RE: Planning Proposal 150 Lismore Road, Bangalow (PP-2021-3615)

Attachment 1. Detailed BCD Comments – Planning Proposal to rezone Lot 4 DP 635505, 150 Lismore Road, Bangalow

RE: Lot 150 – Bangalow Industrial Estate – Further Advice Re Flood Modelling

RE: Updated Planning Proposal, 150 Lismore Road, Bangalow (PP-2021-3615)

Figure 5.4 – Proposed Area to be Rezoned RU1 Primary Production and E3 Environmental Management

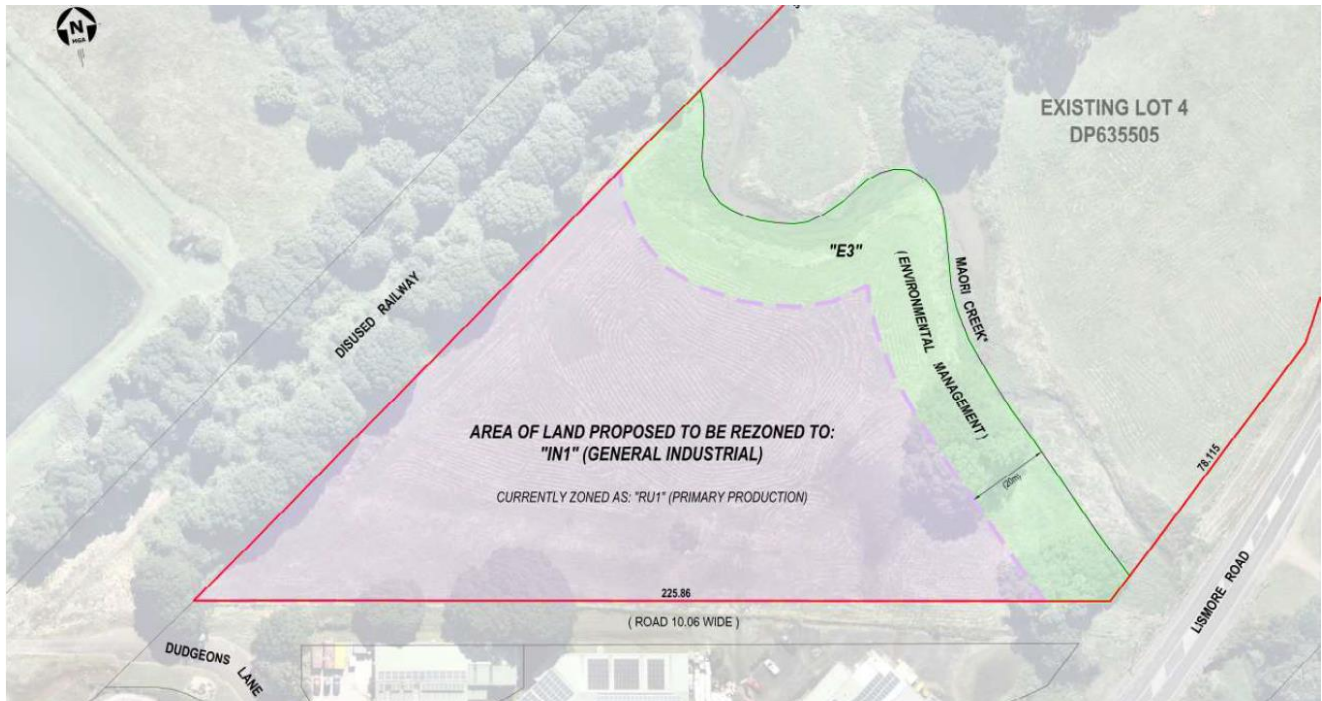
The planning proposal involves rezoning part of Lot 4 from RU1 Primary Production to IN1 General Industrial and rezoning of a 20 metre wide riparian corridor along Maori Creek to C3 Environmental Management as shown in Figure 5.4 in the planning proposal report (see below).

Figure 1. Extract from the Biodiversity Values (BV) Map showing Maori Creek is mapped as having BV values.

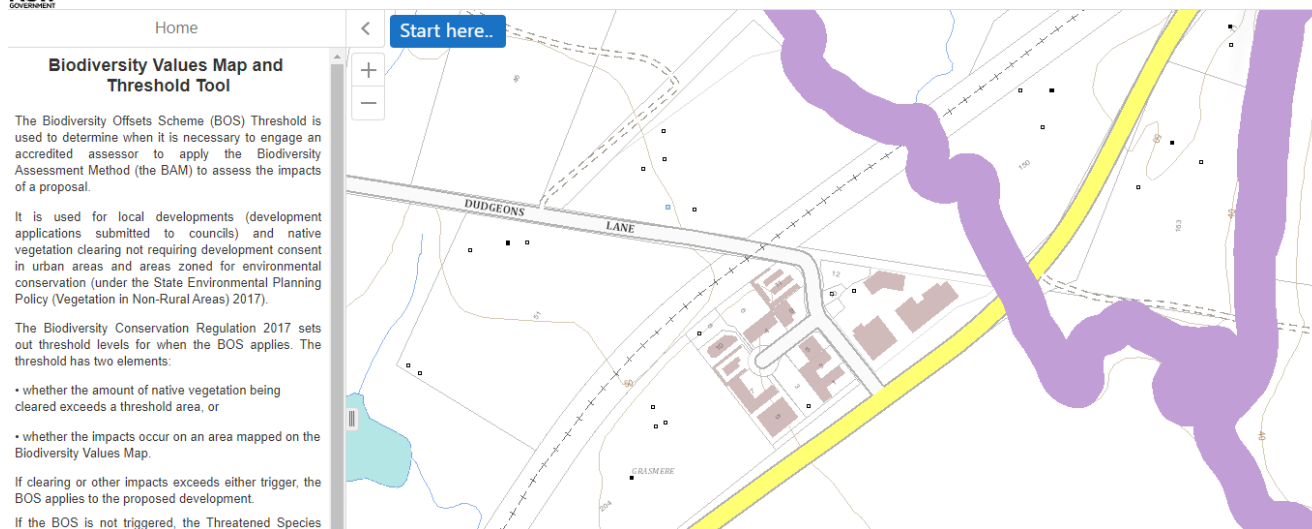
2. As Maori Creek is mapped on the BV Map (see Figure 1 overleaf), which is a component of HEV, land on both sides of Maori Creek should be zoned to C3 – Environmental Management, for a distance of 20m. This would align with the riparian corridor included on the BV Map, and result in a total riparian corridor width of 40m.

Figure 1.1 Rainfall and Stream Gauges

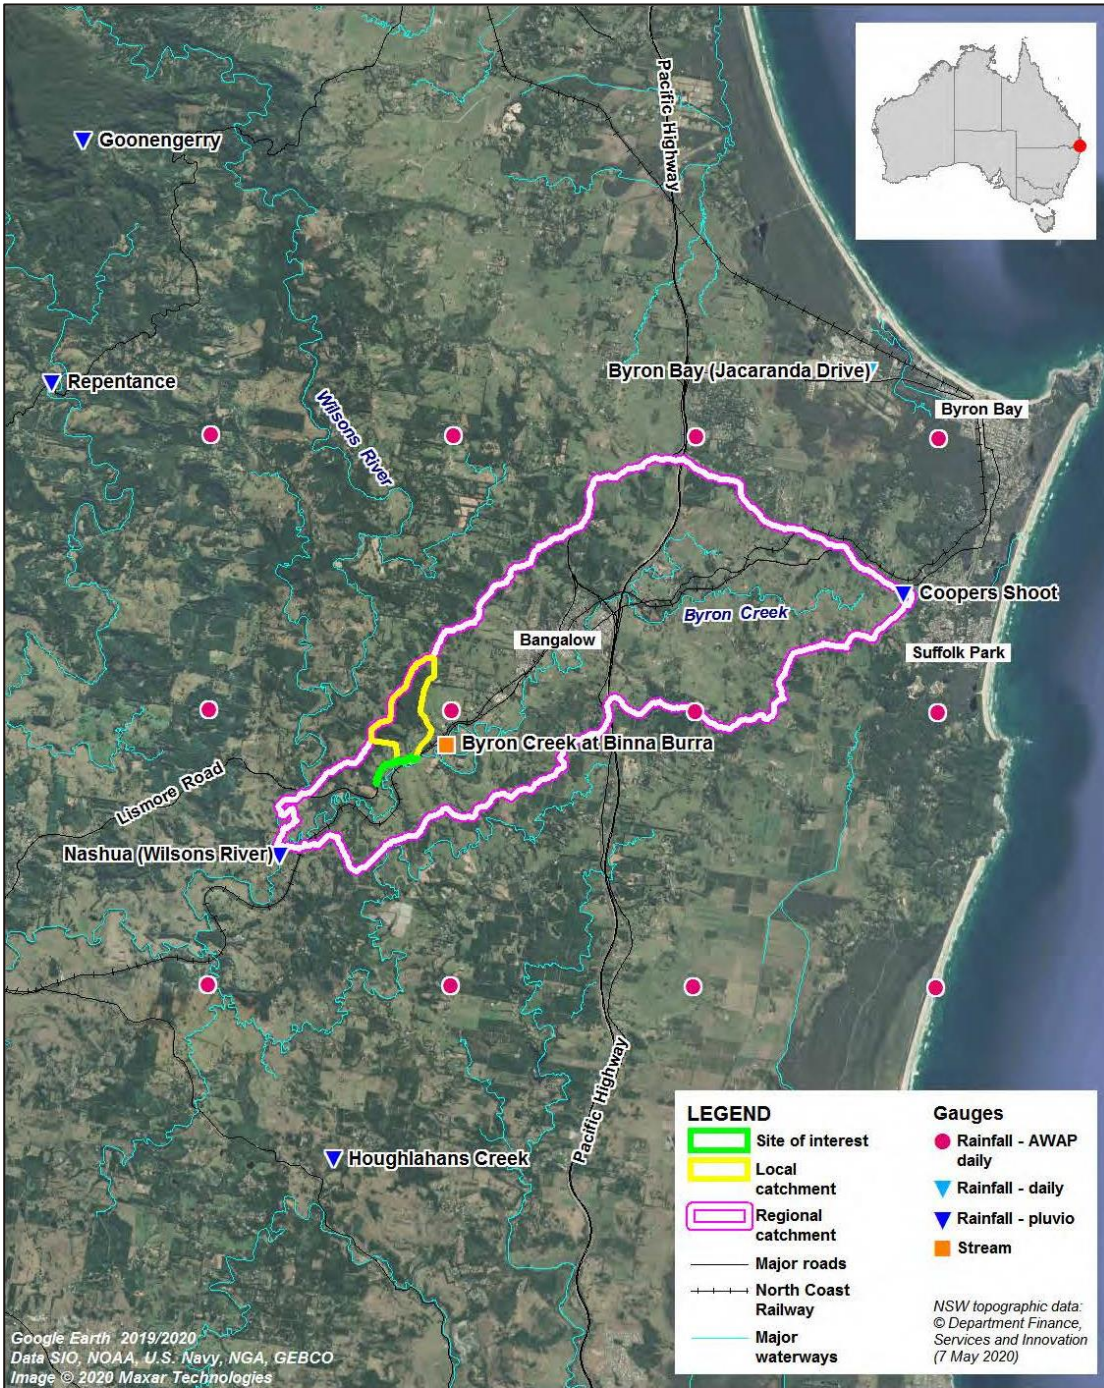
The calibrations used historical recorded rainfall data from the surrounding areas to inform the hydrologic models (Figure 1.1, Figure 1.2). Real stream water level gauging data was used from a recording location in Byron Creek (at Binna Burra). The model terminates a few kilometres downstream of this gauge where it meets the Wilsons River inflow.

Figure 1.3 Rating Curve comparison

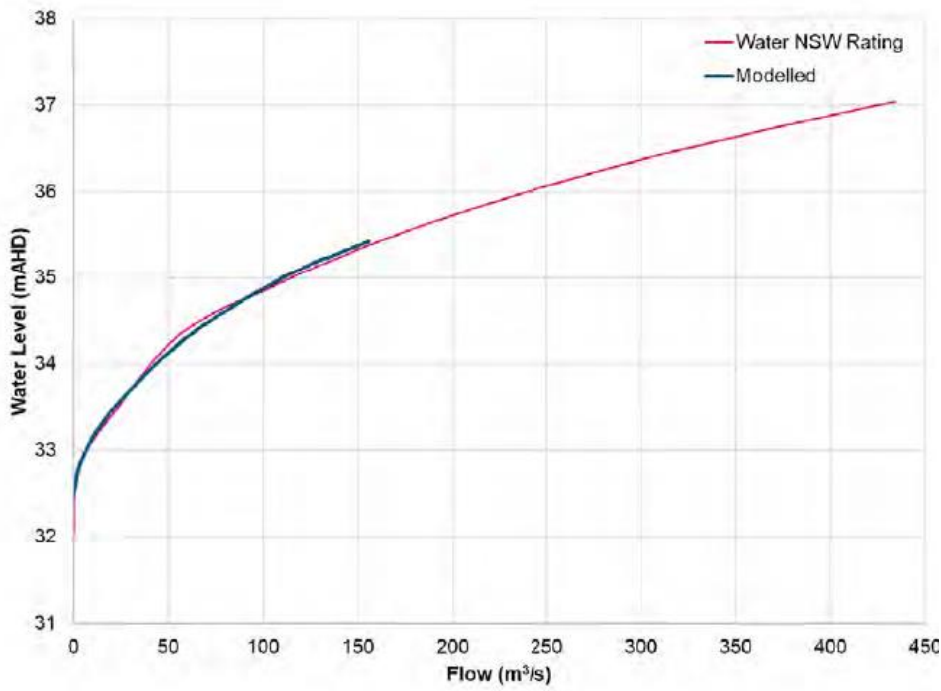
The rating curve for the gauge at Binna Burra was verified with the model and found to be accurate (Figure 1.3). The rating curve allows for conversion of water level at the gauge to a flow rate. Water NSW developed the rating curve for the Binna Burra gauge.

Figure 1.4 Water level calibration results 2017

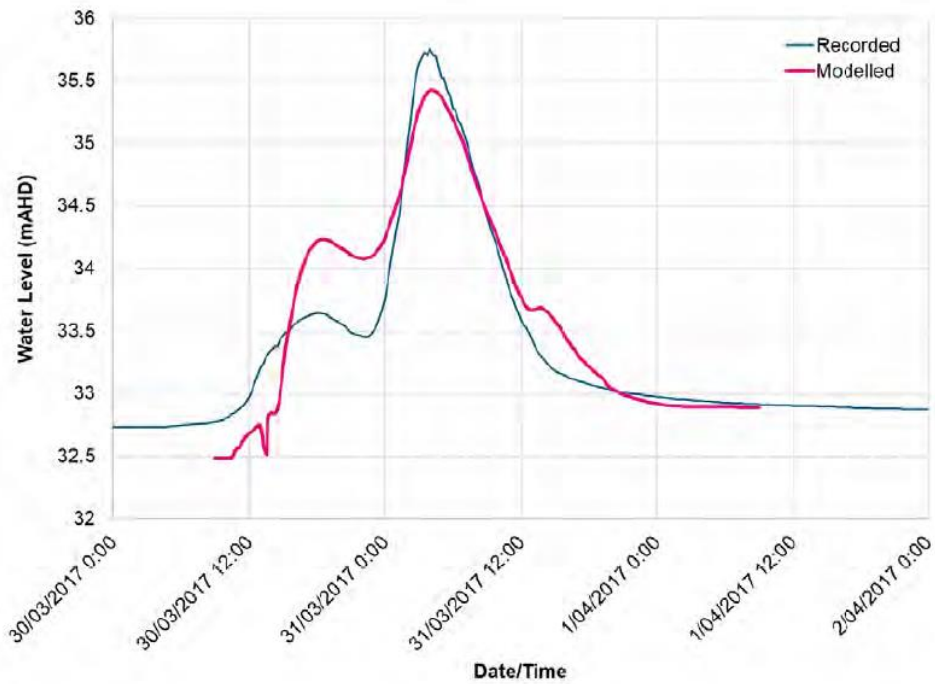
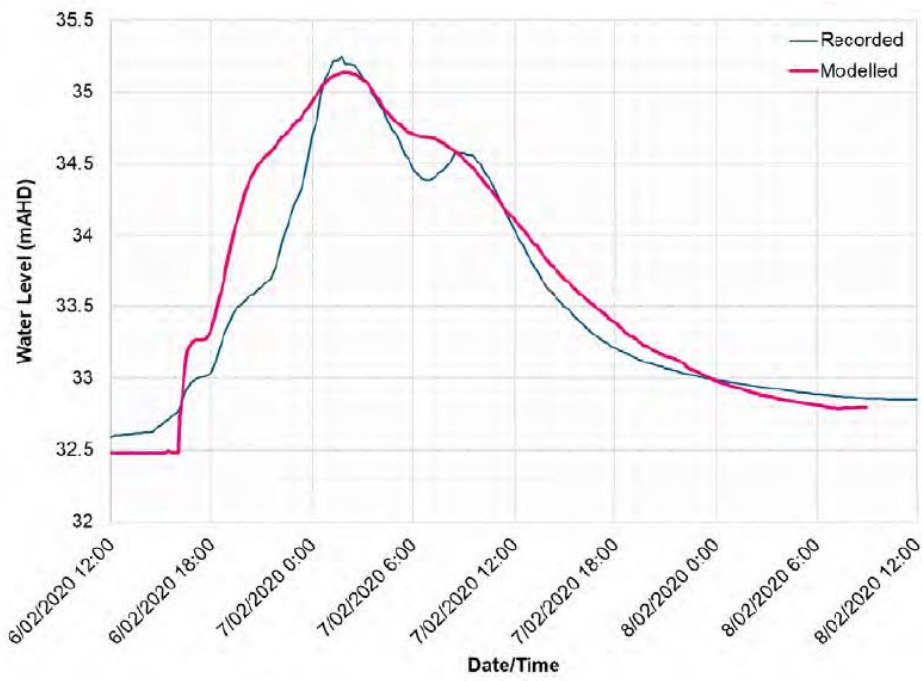
Hydrologic calibration results were considered adequate to drive the hydraulic modelling (Figure 1.4 and 1.5).
